ADDENDUM NO.: 01
PROJECT NAME: DUNNE TECHNOLOGY ACADEMY MODERNIZATION
PROJECT NO.: 05440
CONTRACT NO.: C1566
DATE OF ISSUE: February 27, 2015

NOTICE OF CHANGES, MODIFICATIONS, OR CLARIFICATIONS TO CONTRACT DOCUMENTS

PROJECT DUNNE TECHNOLOGY ACADEMY MODERNIZATION		TITLE REVISE NOTE 7, DETAIL #5	
FGM ARCHITECTS <small>CHICAGO OAK BROOK OFALLON ST. LOUIS</small>	DRAWN Author	DATE 02/26/2015	SHEET NO. CSK-001
	APPROVED Approver	JOB NO. 15-1950.01	ISSUED AS ADD #1
PROFESSIONAL DESIGN FIRM - IL # 184-000350

Title
FIRST FLOOR FURNITURE & WALL MOUNTINGS PLAN

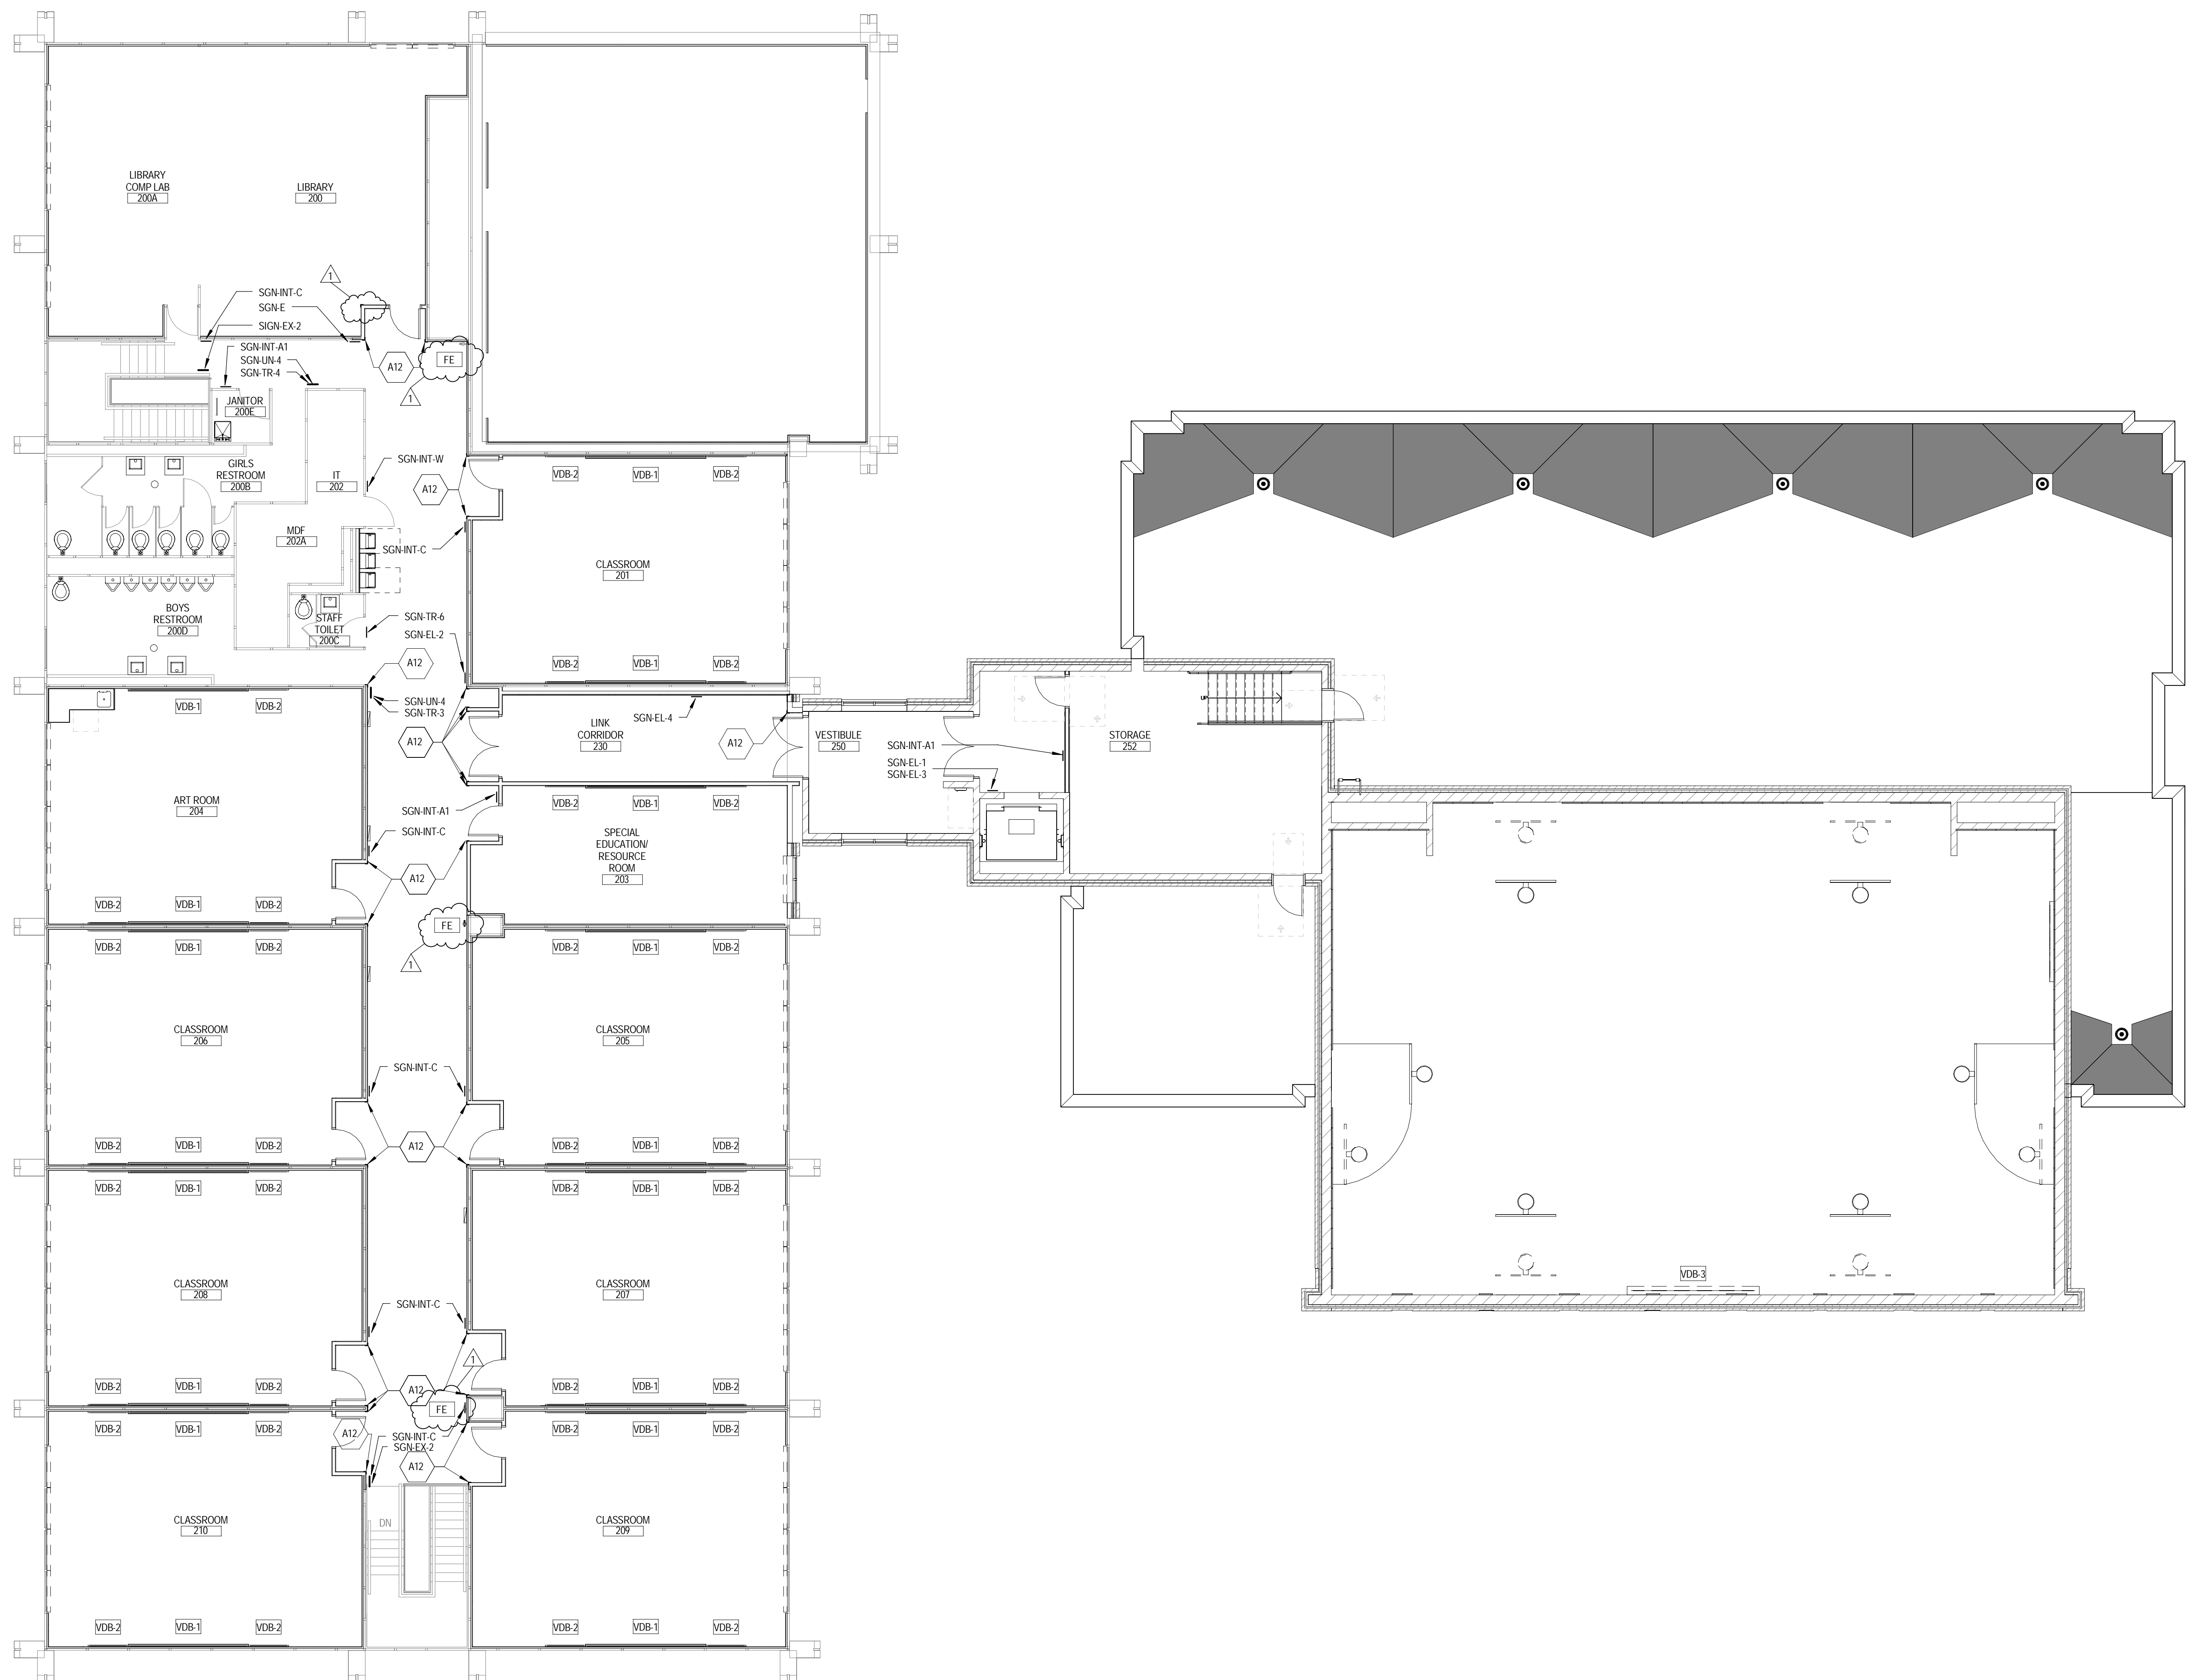
- a. Revised Note A12 to read as follows: "PROVIDE 3" x 3" x 4'-0" HIGH STAINLESS STEEL CORNER GUARD."
 - b. Added corner guards at the locations identified in the revision clouds.

- c. Added "NO SMOKING" signs. See ASK-006 for detail.
14. SHEET A9.2.0 – SECOND FLOOR FURNITURE & WALL MOUNTINGS PLAN
- a. Revised Note A12 to read as follows: "PROVIDE 3" x 3" x 4'-0" HIGH STAINLESS STEEL CORNER GUARD."
